HISTORIC AND DESIGN REVIEW COMMISSION

Agenda Item No: 8

HDRC CASE NO: 2016-214
ADDRESS: 200 W JONES AVE
LEGAL DESCRIPTION: NCB 1036 BLK 1 LOT 2 (SAN ANTONIO MUSEUM OF ART)
ZONING: FBZ T6-2 H HE RIO-2
CITY COUNCIL DIST.: 1
DISTRICT: Old Lone Star Brewery Historic District
LANDMARK: Lone Star Brewery
APPLICANT: Jeffrey Ryan/Jackson & Ryan Architects
OWNER: San Antonio Museum of Art
TYPE OF WORK: Mechanical equipment addition
REQUEST:

1. Pipe Runs from New Central Utility Plant - Stair One

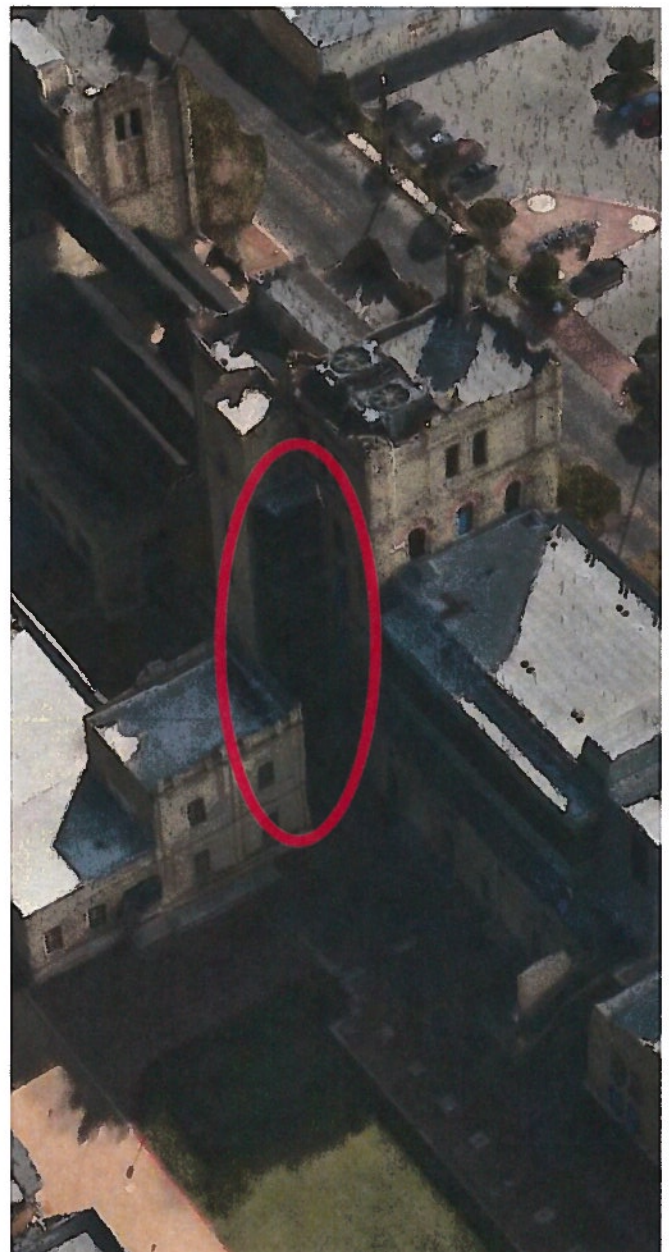
- a. The applicant has proposed to install a painted aluminum panel enclosure to house chilled and hot water piping on the north elevation of the west tower on the original structure. This piping will be collocated with an existing stair tower addition. While the applicant is located this pipe run on the façade of the primary historic structure, the applicant has proposed to locate it adjacent to an existing stair tower which is an egress addition from 1980. Additionally, this location is on the rear of the primary historic structure and will include materials to match the addition of 1980. Staff finds this piping enclosure is appropriate consistent with the Guidelines for Additions, 5.A.i.

Pipes to run outside of stair enclosed in framed walls and finished to match metal terms of the stair closure.

1. Pipe Runs from New Central Utility Plant - LAAC/East Tower

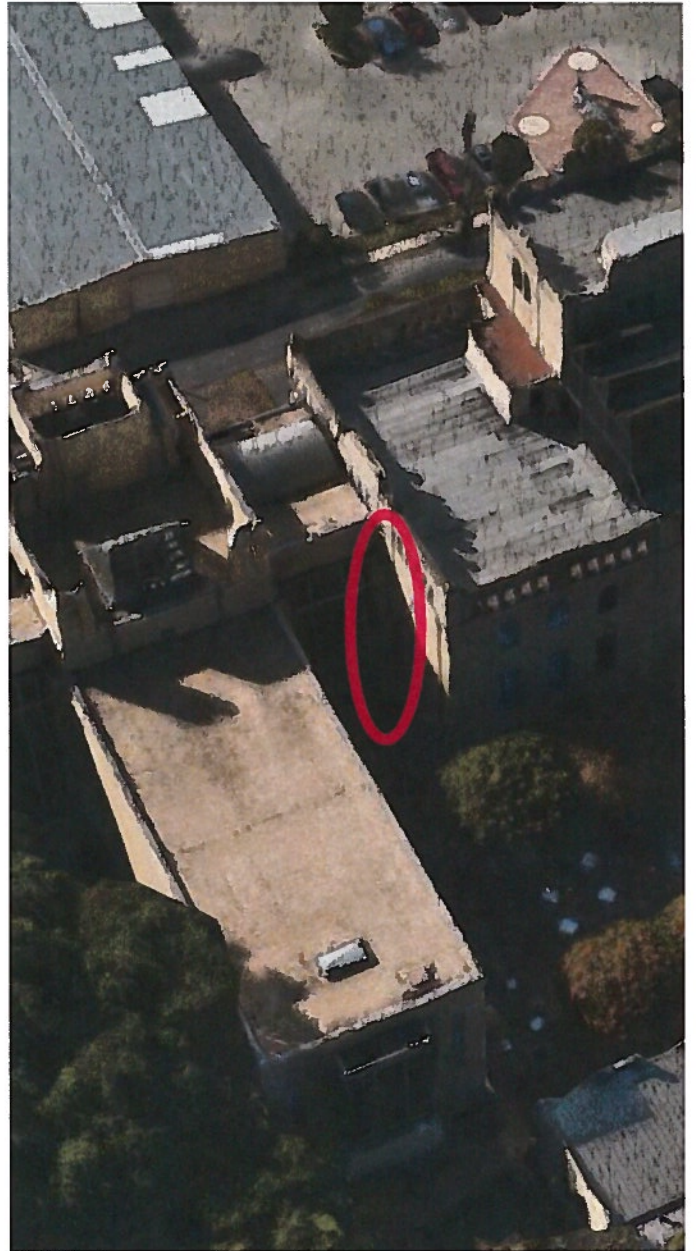
- b. On the north side of the Latin American Cultural Center (LACC), the applicant has proposed to install piping with zinc grey galvalume enclosures. Each of the two pipes will feature a diameter of six (6) inches and are to match the existing piping located on the addition. These pipes will not in any way be attached to the primary historic structure. Staff finds this proposal appropriate and consistent with the Guidelines for Additions, 5.A.i.

Two 6" Pipes to run outside of the north face of the pilaster adjoining the East Tower. Pipes will be secured to the face of the pilaster with brackets to match the adjacent pipe beam attachments at the storefront glazing. The pipes and brackets are also to be painted to match that pipe beam.

2. New Elevations with the Corrugated Aluminum Siding

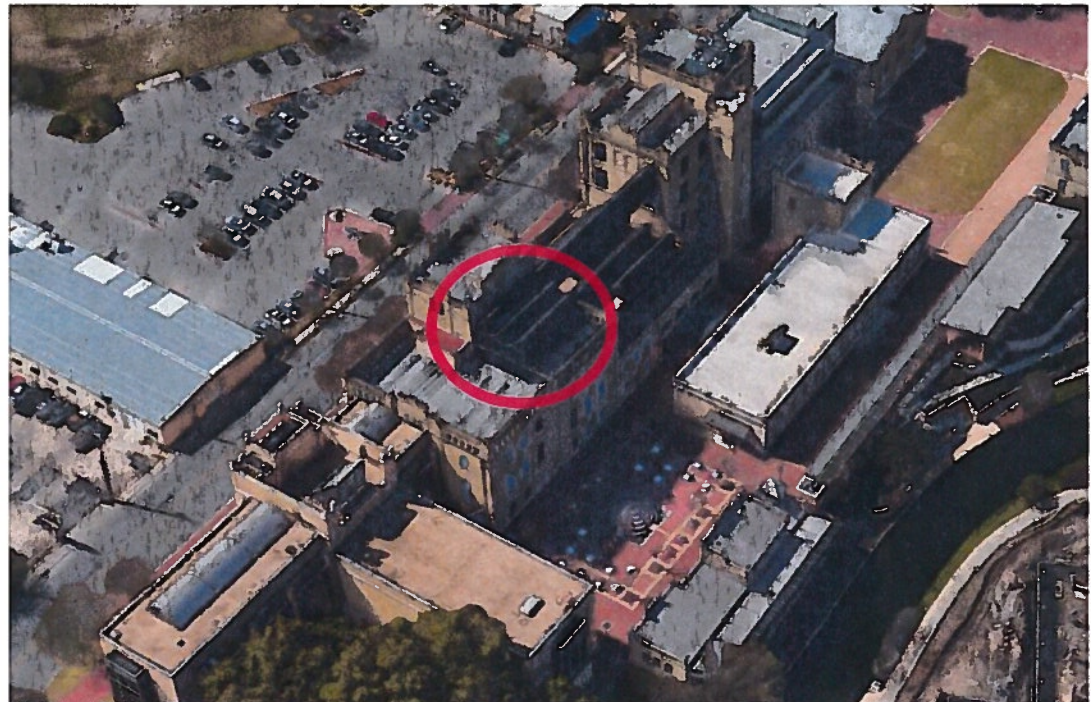
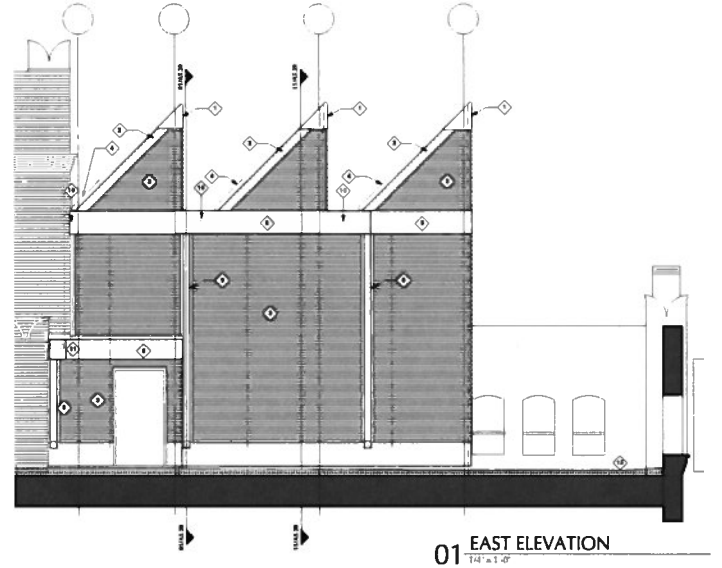
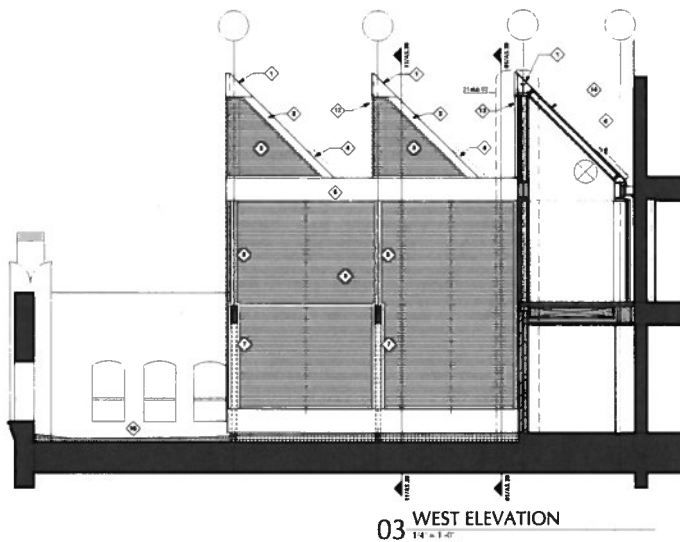
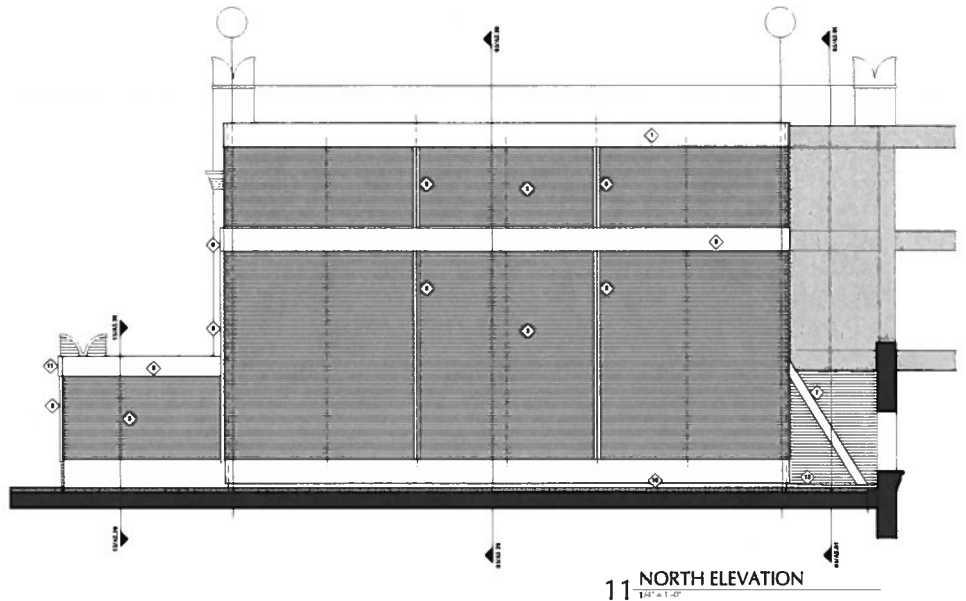
- c. On the fourth and fifth levels of the east tower, the applicant has proposed to replace the existing black aluminum panels and single, silicone glazed tinted glass; both products of the 1980 addition. The applicant has proposed to replace these façade elements with new, coated galvalume grey siding to match the exterior of the Lenora and Walter F Brown Asian Art Wing. The applicant has noted that the elevations and massing of the existing structures will not change; only the materials. Staff finds the applicant's proposal appropriate and consistent with previous materials in terms of their industrial context.

The original addition on level 4 & 5 of the north side of the East Tower will be renovated to improve its interior environmental conditions. The result is to replace the existing floor-to-ceiling glass with insulated walls with interior finished of museum grade gypsum walls and an exterior finish of corrugated aluminum panels that matches the existing Lenora and Walter F. Brown Asian Art Wing.
